Addendum #1 – April 3, 2020
Contract WR20-002
2019 Water Utility Capital Works

- 1) **Clarification:** Metro Vancouver has added further specifications and notes in relation to the proposed watermain's crossing underneath the Metro Vancouver's 450mm Sanitary Trunk Sewer along North Bluff Road. Changes are reflected on attached drawings and supplemented by attached Metro Vancouver documents:

- Tender Drawing Sheet 3 of 4 Revision A – Issued for Tender with attached Tender Drawing Sheet 3 of 4 Revision B – Issued for Addendum #1

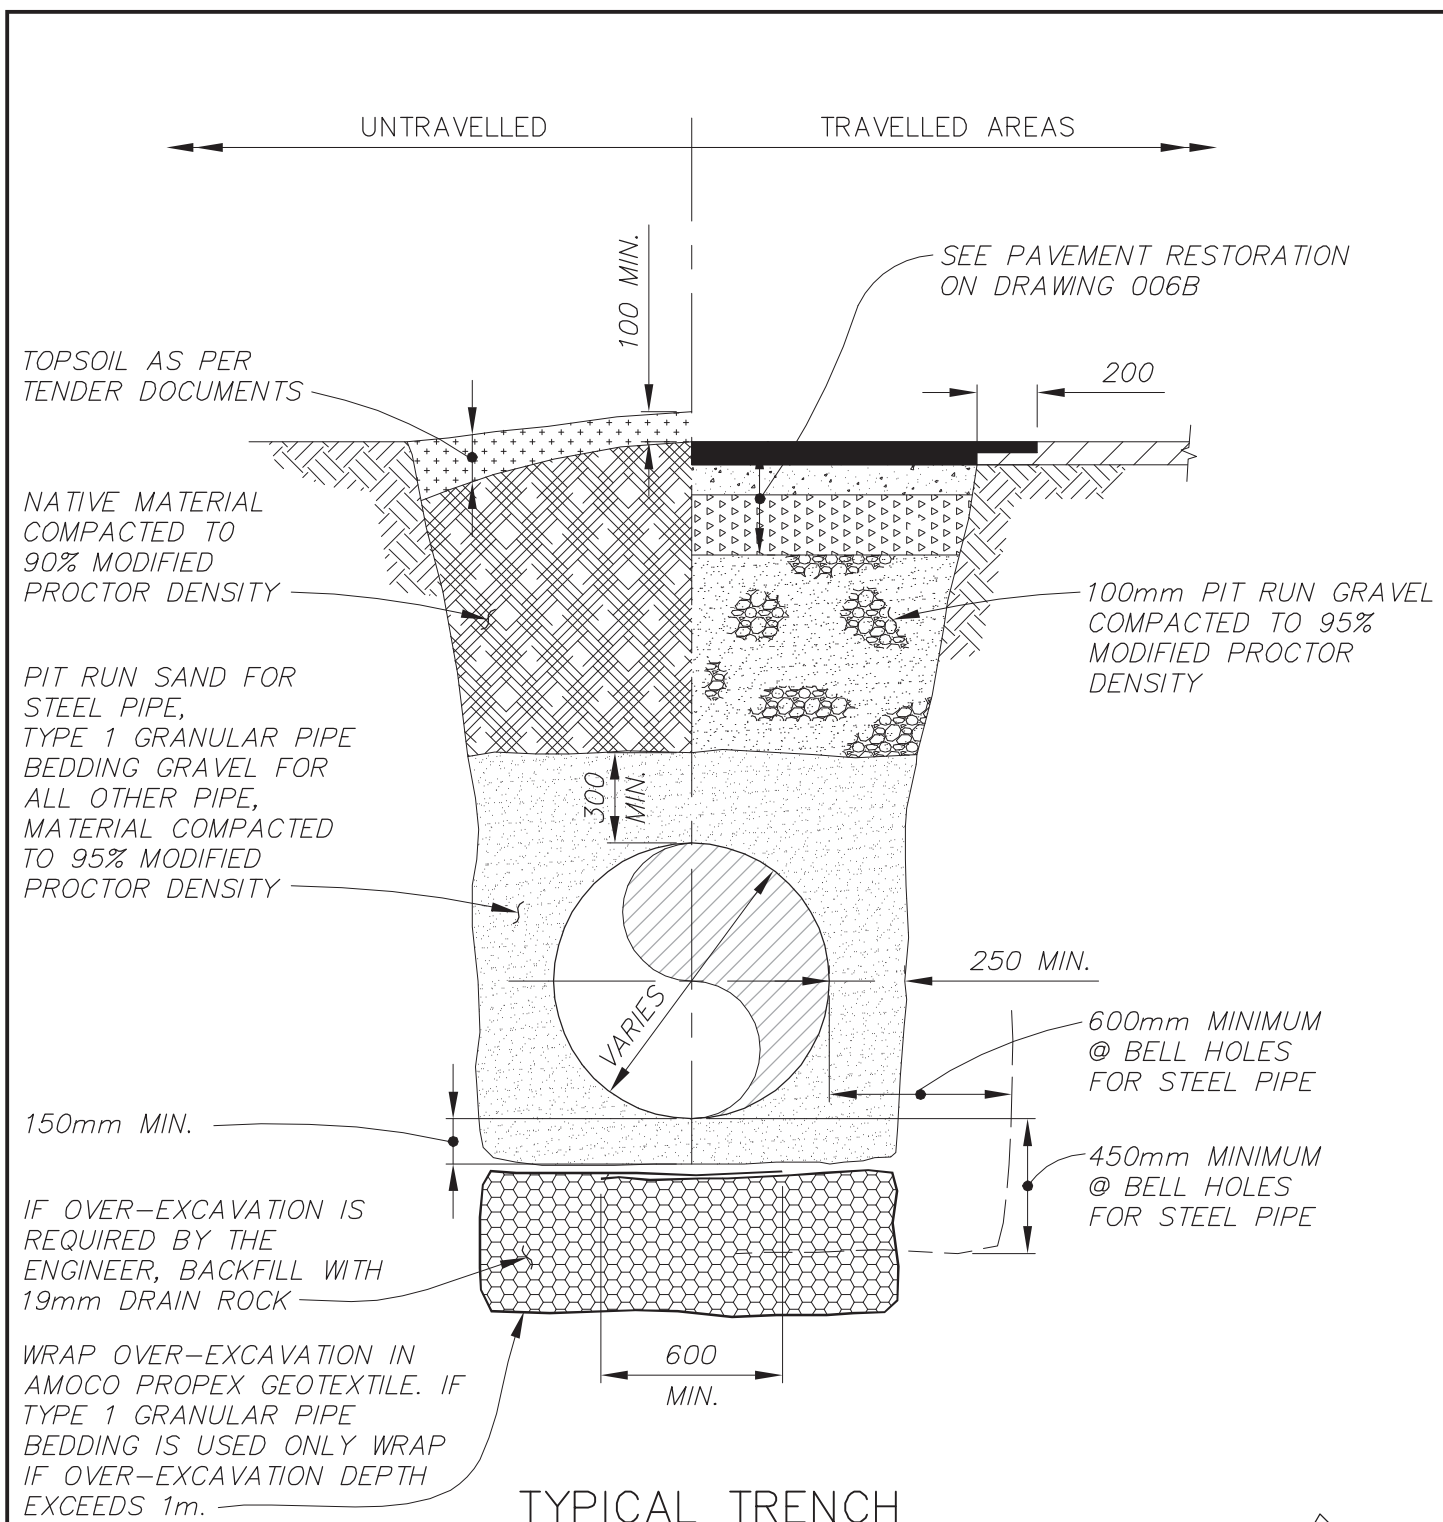
- 5) **Question:** We would like clarification as to the type of Joint restraints to be used. Schedule of quantities, Item 33.08B refers to Uni-flange 1350 c/w thread rods, while Drawing 19-1006-W2 says under Joint restraint Notes, Uni-flange 1500 series "circle lock" type restraints. Which one is correct?

Answer: Drawing 19-1006-W2 is correct. Uni-flange 1500 series "circle lock" type restraints will be used.

PAVEMENT RESTORATION

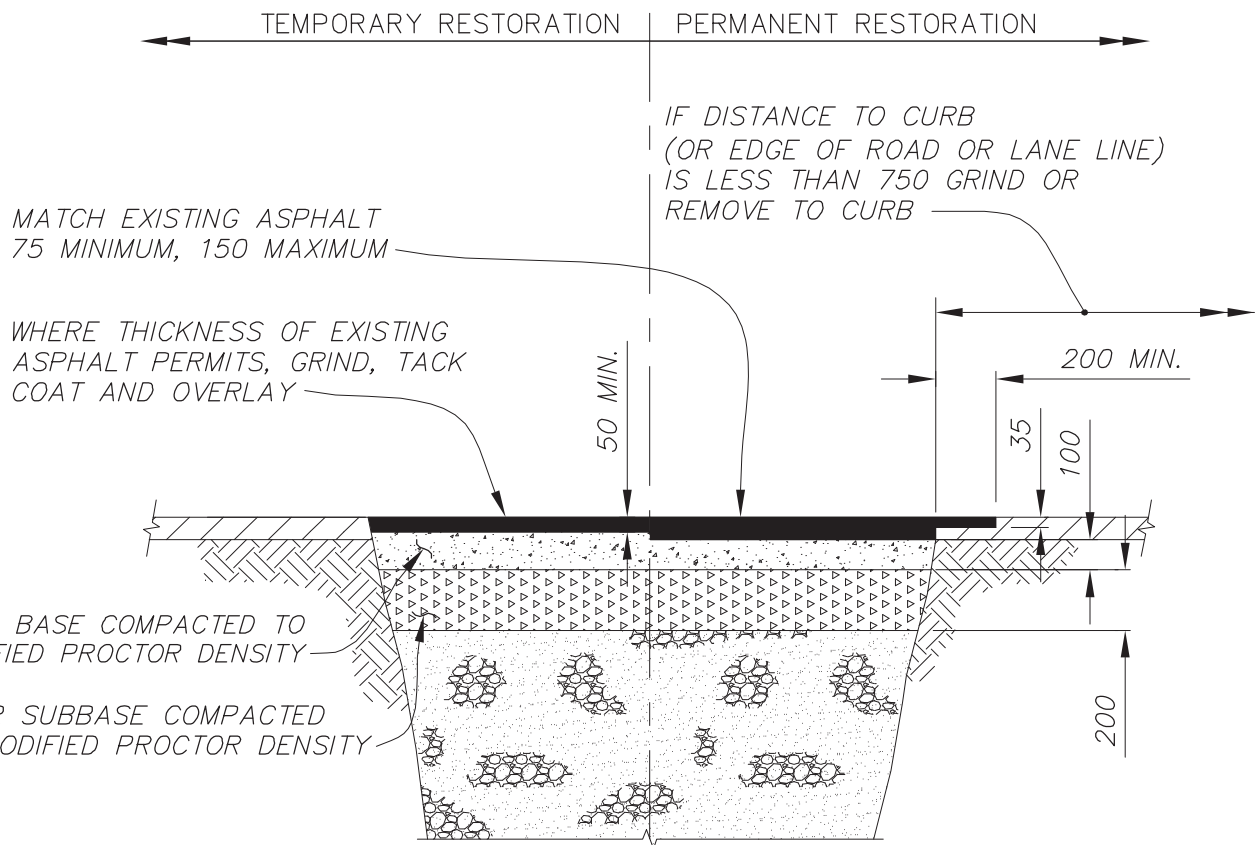
- Added Metro Vancouver Notes:
 - Metro Vancouver Pipe Bedding, Backfill and Surface Restoration standards per Metro Vancouver (see attached GVWD&SDD Typical Trench and Pavement Restoration Details)
 - Exposed Metro Vancouver pipe support and shop drawing requirement
 - Field locate hydrovac requirement for centerline of Metro Vancouver sewer
 - Contact Information for Metro Vancouver representative.
- Added vertical deflection in watermain underneath 450mm sanitary trunk main to introduce 0.6m separation.
